## **Service Bulletin**

**No. :** MZ03-002

**Model:** CC3000/CC4000

**Subject:** Tray open problem

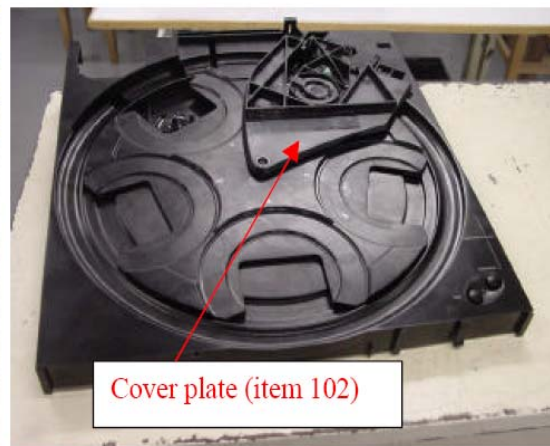
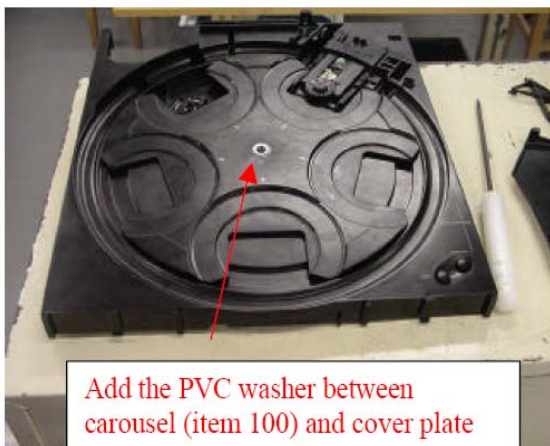
2. Carrousel jamming due to external resistance driving the cam-wheel to shift from original position.

To resolve Reason #2: Add a 0.9 +0/-0.1mm PVC washer between the carrousel and covering plate.(see pictures below)The PVC washer dimension is inner "d" = 8mm and outer "D" = 15mm. (Parts No. 279W012010)
